SUBJECT: Forwards response to NRC 980626 RAI re analysis to evaluate effects of one svc water pump available - post-LOCA.

Subject: Response to Request for Additional Information (RAI) Related to the Effects of
One Service Water Pump Available - Post-Loss-of-Coolant Accident (TAC No.
M84947)
R. E. Ginna Nuclear Power Plant
Docket No. 50-244

RG&E RESPONSE TO NRC 6-26-98 RAI

FIGURE 3
CONTAINMENT PRESSURE & TEMPERATURE RESPONSE

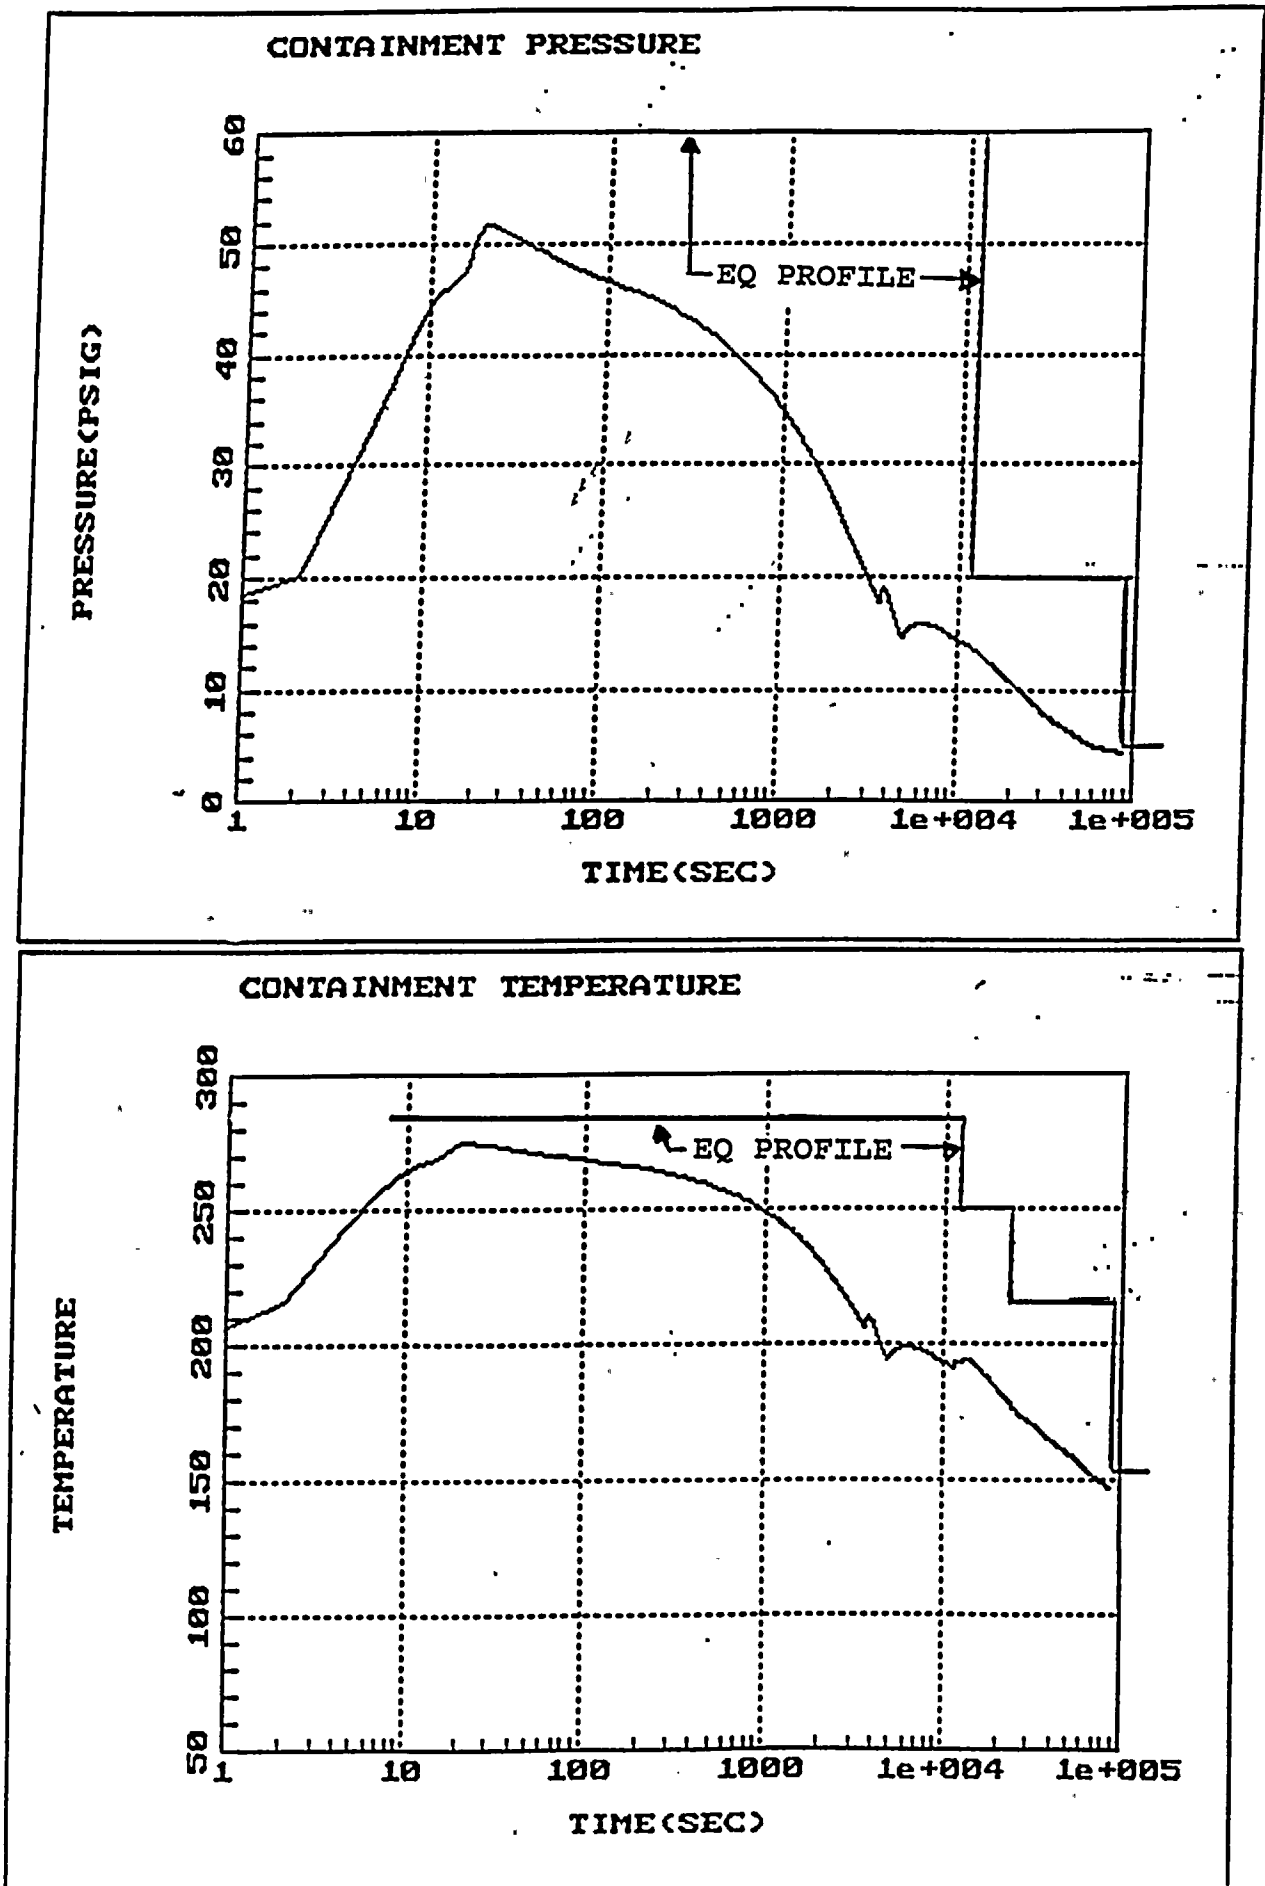
In the current UFSAR, you state that two component cooling water heat exchangers are expected to receive SW flow in the post-LOCA recirculation phase. However, procedure ES-1.3, Revision 15, instructs operators to isolate one CCW heat exchanger and have both CCW Pumps operating. Quantitatively compare the cases when both heat exchangers are operating and when one CCW heat exchanger with two CCW Pumps is operating. Provide any necessary documentation to demonstrate adequate heat removal from the containment sump to the SW system.

The results of this reduction in RHR heat removal capability in combination with the reduction in CRFC heat removal capability in the LOCA Recirculation Phase have been used to re-analyze the long term containment pressure/temperature response. The results of the containment re-analysis provided in Figure 3 are consistent with the results originally provided to the NRC in References 8-9. Specifically, although the long term containment pressure and temperature reduction is slower than that obtained with 2 SW Pumps, the containment profiles are still bounded by the EQ profiles used to qualify components in containment for post-LOCA conditions.
